HORSHAM DISTRICT COUNCIL CONSULTATION

TO:	Horsham District Council – Planning Dept
LOCATION:	Menzies Wood Farm Okehurst Lane Billingshurst
DESCRIPTION:	Full planning permission for demolition of existing workshop, barn and offices and erection of a new barn and workshop building and office building and creation of open storage along with the full enclosure and refurbishment of existing barn for the continuation of uses on site falling within use classes B1(c) and B8, including the repair and maintenance of trailers and ancillary equipment; assembly of new trailers, horse boxes (including those with accommodation on board); trailer, motorhome and horse box conversions; pre sales work and customer collections; and the preparation and loading of trailers and horse boxes for export following grant of DC/18/0661
REFERENCE:	DC/25/0362
RECOMMENDATION:	Holding Objection/More information
SUMMARY OF COMMENTS & RECOMMENDATION:	
Given the context and planning history of the site, no concerns are raised with the principle of development. However, clarification is requested on the final sitting of the proposed office as the plans are not consistent. The block plan shows the proposed office buil

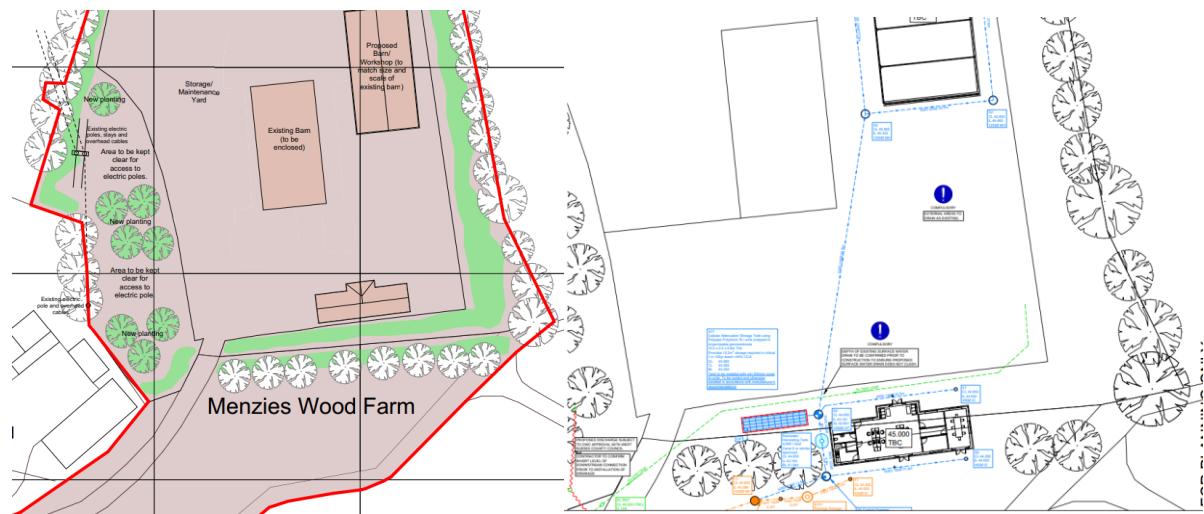
Screenshot below for reference:
